PRELIMINARY PLAT						
WINDMILL RIDGE 3-A						
ROCKWALL, TEXAS						
JOHN C. GIBSON CO., INC. CONSULTING ENGINEERS						
9510 Military Parkway Dallas, Texas 75227						
DESIGN	DRAWN	DATE	SCALE	NOTES	FILE	NO.
A.D.M.	A.D.M. R.J.H.	DEC. 7, 1984	1" = 100'		WINDMILL RIDGE

RE: Windmill Ridge Estates No. 3A

Subject: Windmill Ridge, Phase 3A Preliminary Plat

PRELIMINARY PLAT						
WINDMILL RIDGE 3-A						
ROCKWALL, TEXAS						
JOHN C. GIBSON CO., INC. CONSULTING ENGINEERS						
9510 Military Parkway Dallas, Texas 75227						
DESIGN	DRAWN	DATE	SCALE	NOTES	FILE	NO.
A.D.M.	A.D.M. R.J.H.	DEC 7, 1984	1" = 100'			WINDMILL RIDGE

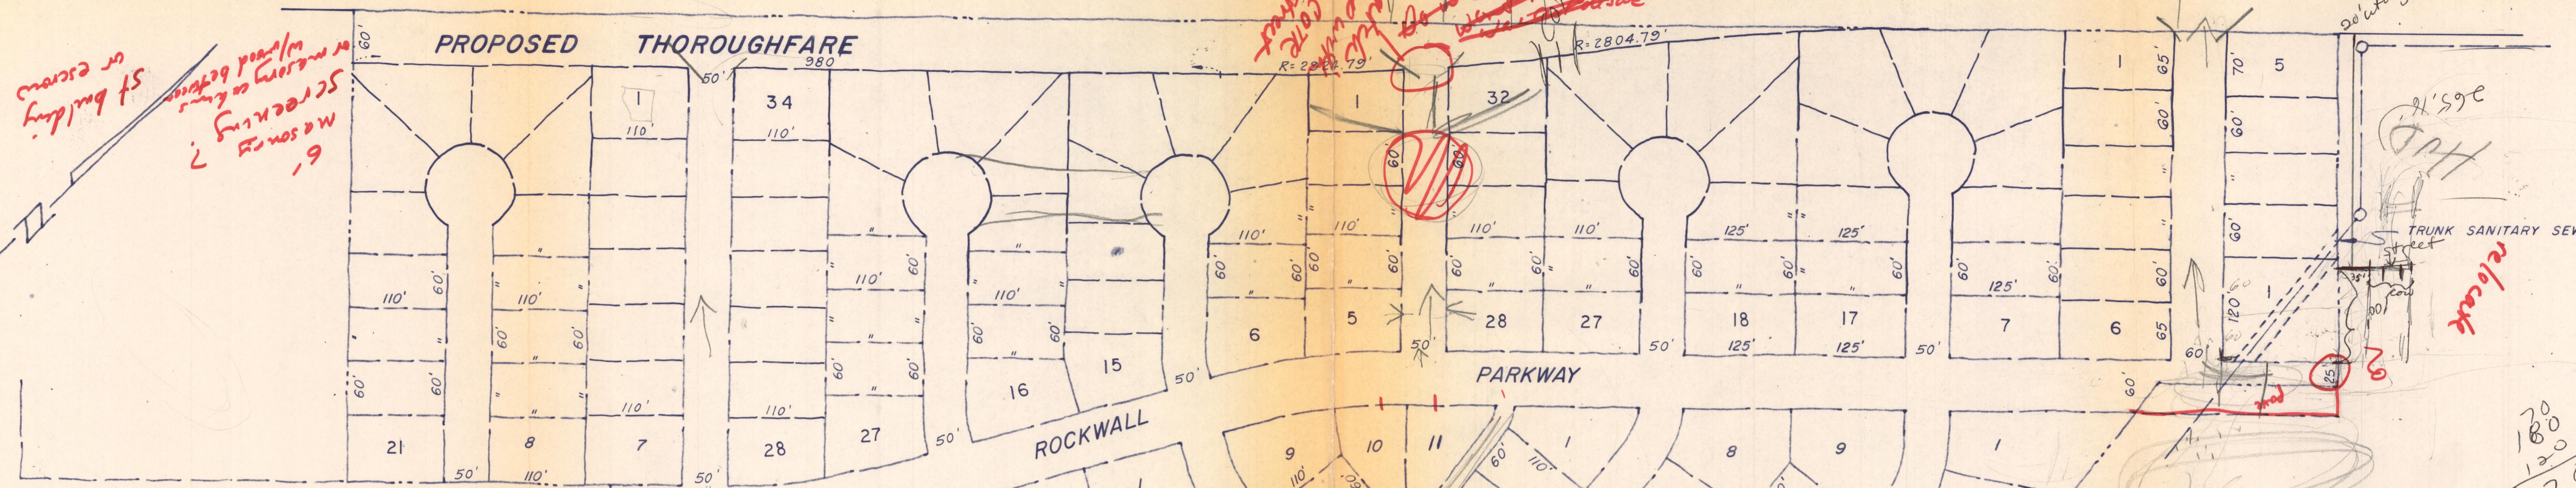
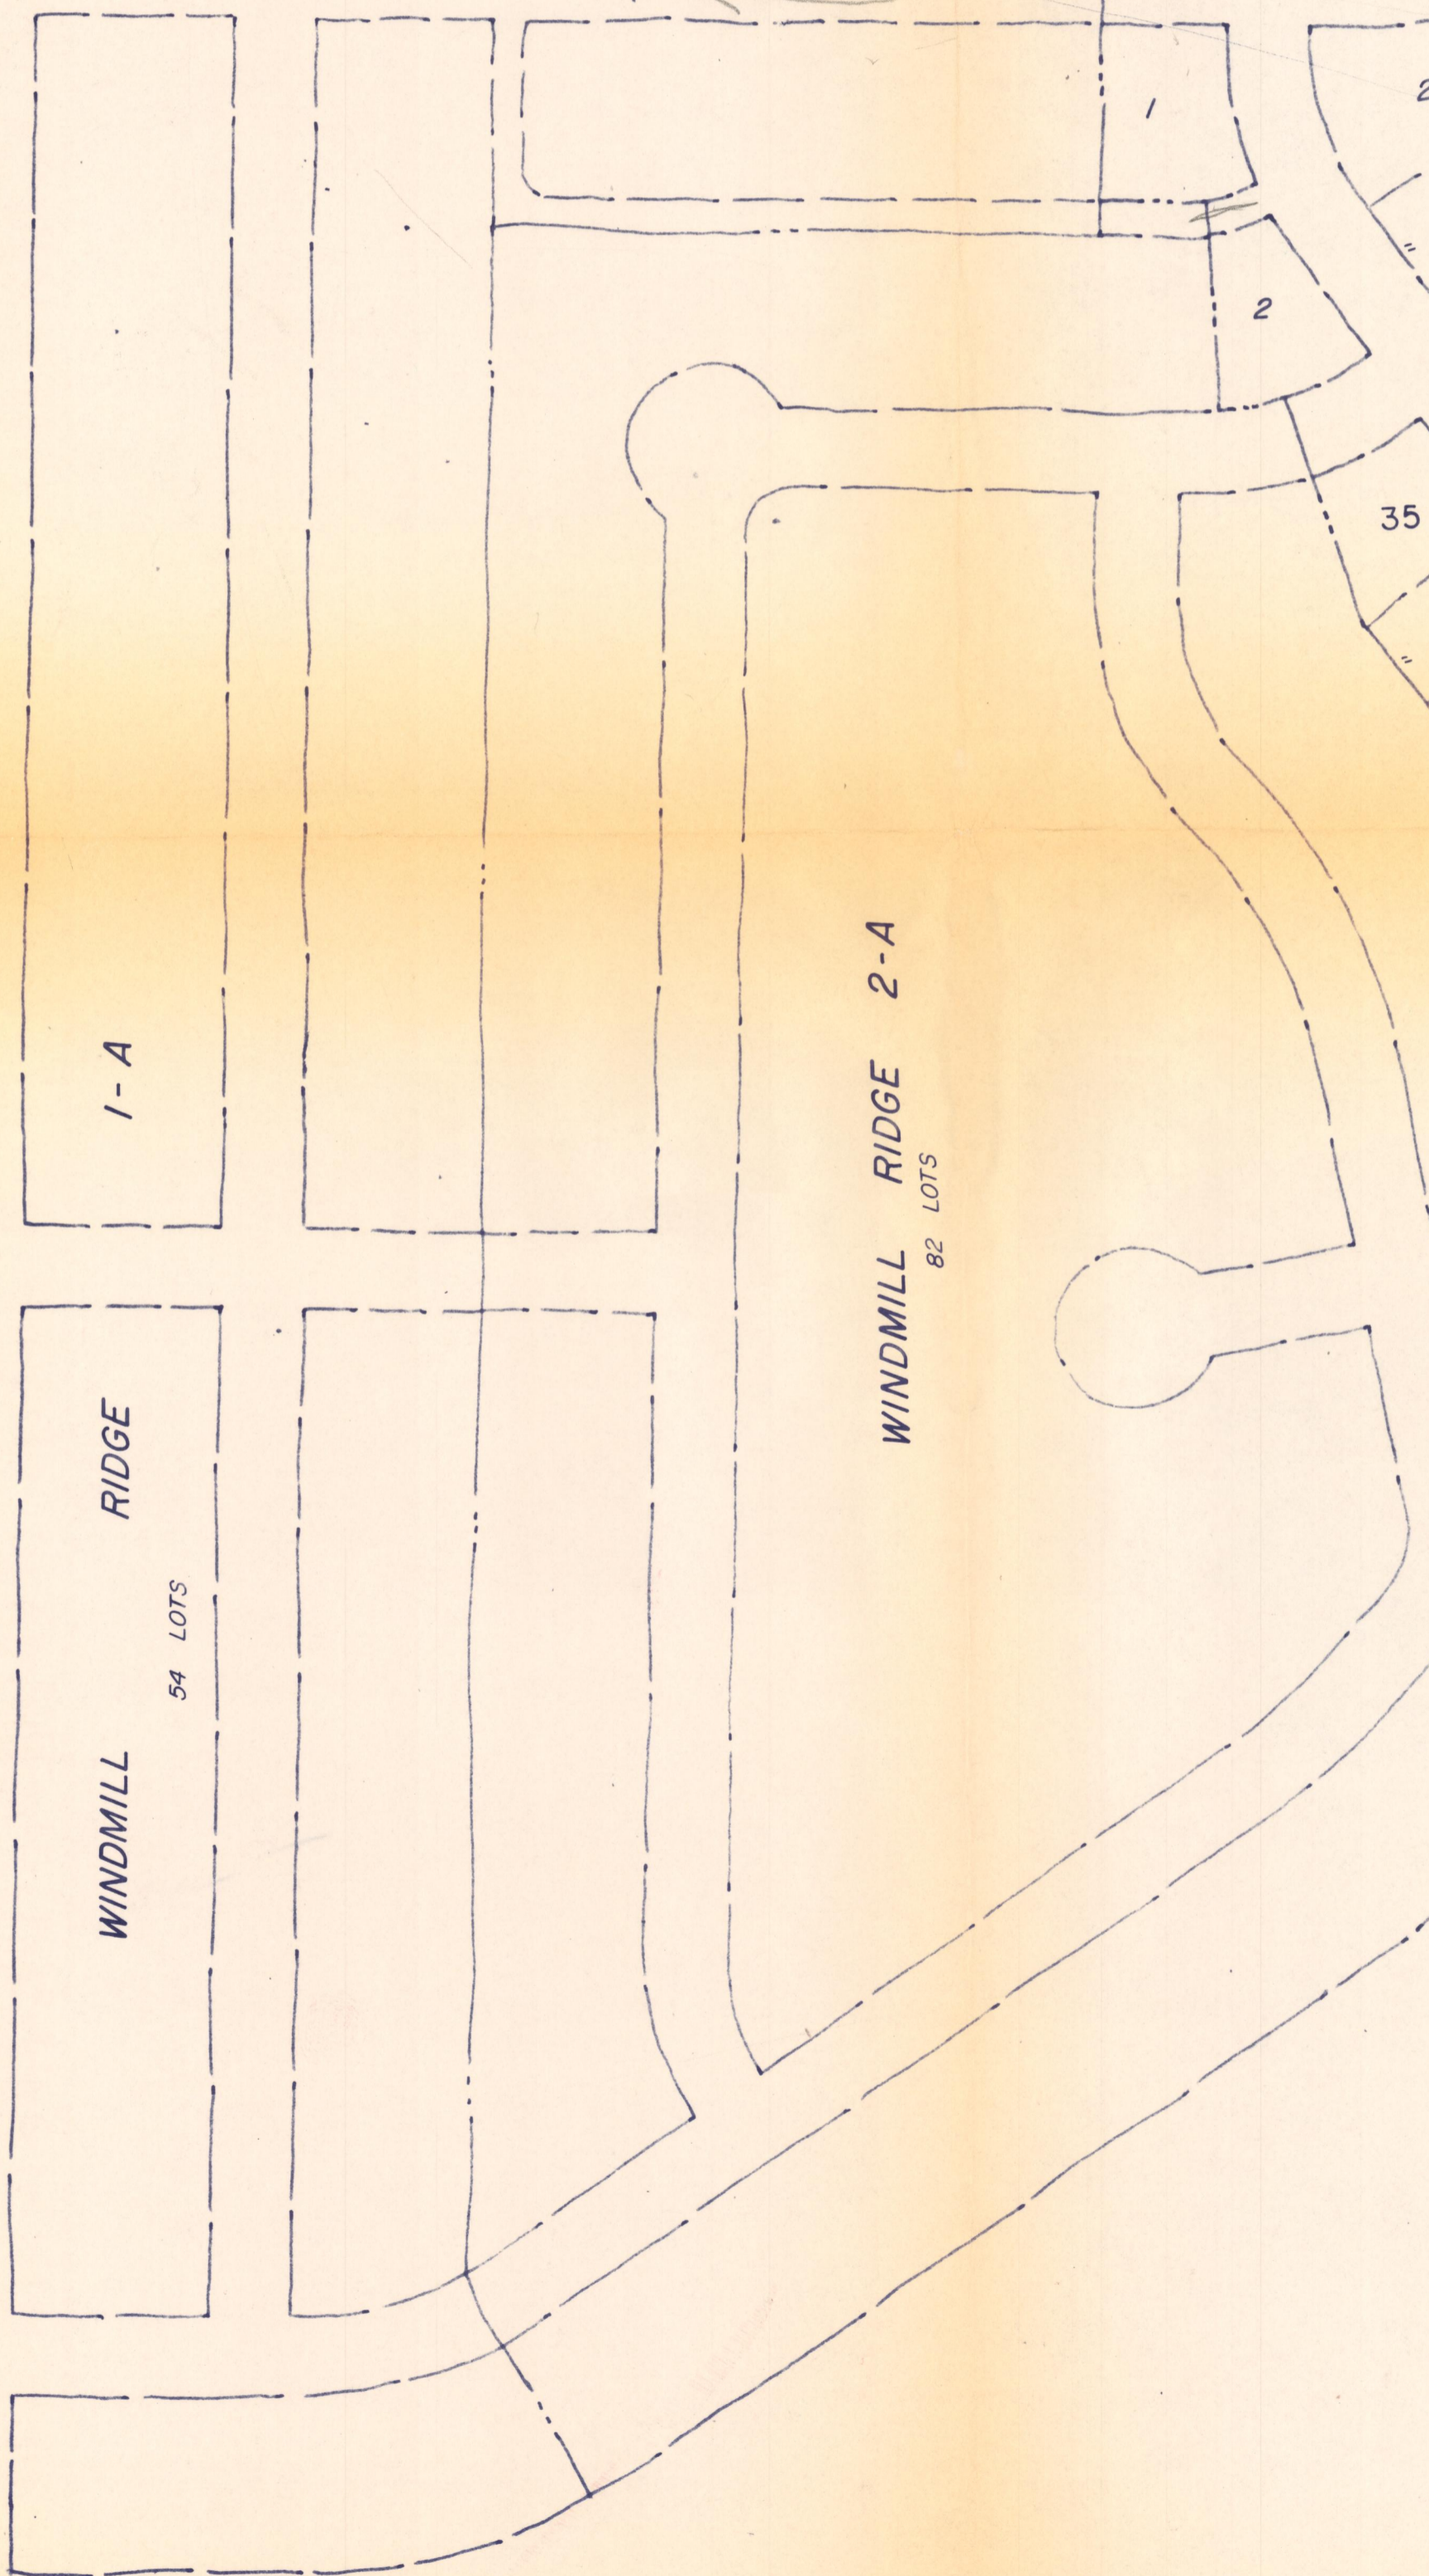
front setback 25'
 side " 5'
 rear " 15'
 min pky 2' limit
 max height 2 1/2 stories
 max lot coverage 35%

1-54
 2A-82
 201
 338-OK

PRELIMINARY PLAT						
WINDMILL RIDGE 3-A						
ROCKWALL, TEXAS						
JOHN C. GIBSON CO., INC. CONSULTING ENGINEERS						
9510 Military Parkway Dallas, Texas 75227						
DESIGN	DRAWN	DATE	SCALE	NOTES	FILE	NO.
A.D.M.	A.D.M. R.J.H.	DEC. 7, 1984	1" = 100'		WINDMILL RIDGE

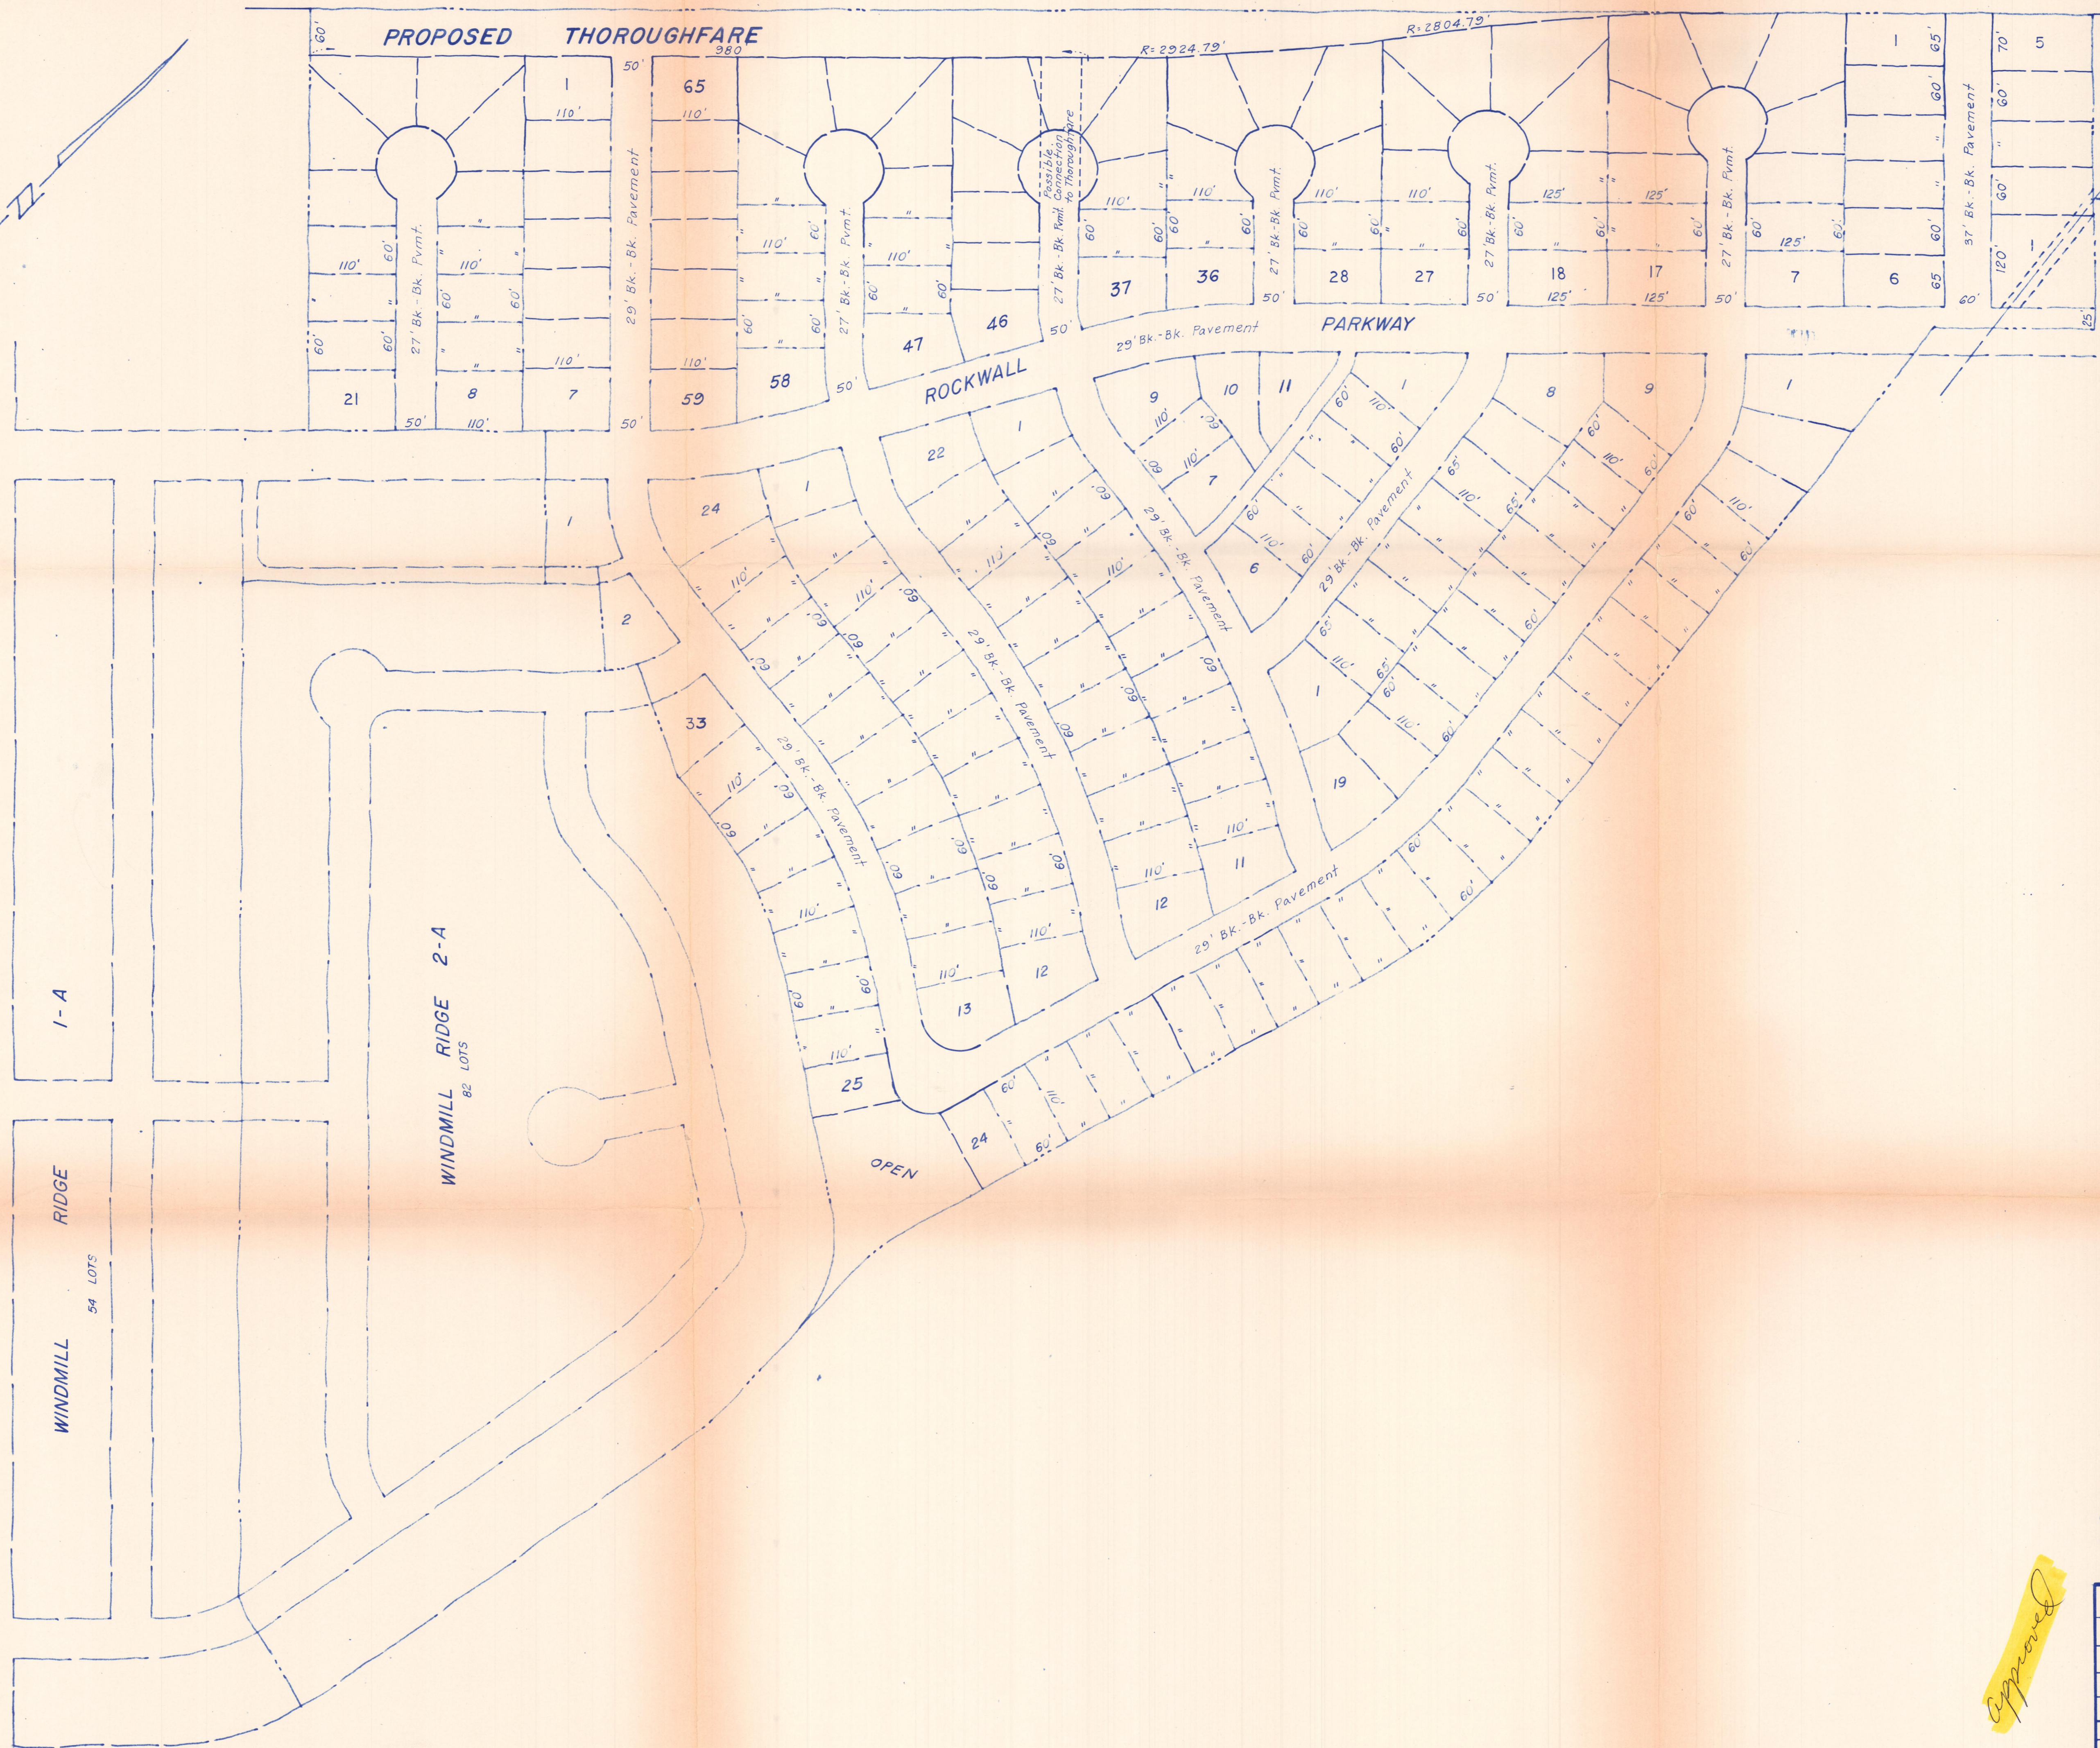
Attached is a copy of the preliminary plat for the property to the south of the Church on the Rock. The applicant is showing some right-of-way dedication for the 6-lane divided on the north. He is asking for a new entry onto the road in the middle of his property. I judge this to be 100 - 150 feet from the road on the west side of the Church on the Rock. Is this sufficient separation or should the road be a cul-de-sac?

1. Relocate trunk sewer line.
2. Pave Rockwall Parkway to full width to edge of property.
3. Street radius too tight on southeast corner of plat.
4. Possible entry to park through flood plain lots on curve.
5. Discuss new entry onto future 6-lane divided roadway after recommendation received from traffic planner. Currently shown approximately 150 ft. offset from street serving Church on the Rock on the north side.

This revision relocates the center entry (along the proposed P6D thoroughfare) of this development, to approximately 400 feet west of the proposed collector on the west side of the Church on the Rock. This relocation prohibits the potential traffic problem with closely spaced intersections, allows three future median openings to the subdivision, and enhances the traffic flow throughout the subdivision.

1. two street entries to thoroughfare
2. park entry instead of two floodplain lots
3. redesigned curve radius
4. Rockwall Parkway paved to edge of property
5. lot with sewer line enlarge to provide sufficient buildable area
6. six-foot masonry screen along thoroughfare as these lots are final platted
7. money placed in escrow for 24 foot of paving with curb and gutter and storm drainage as lots along thoroughfare final platted
8. phases denoted on first phase final plat

- On February 18, 1985 the City Council approved your preliminary plat with paving of 24 ft. of the proposed 6-lane divided roadway or escrow of funds at the time of final plat; Rockwall Parkway 29 ft. of paving; two entry streets to 6-lane divided; and 6 foot masonry screening wall along 6-lane divided.
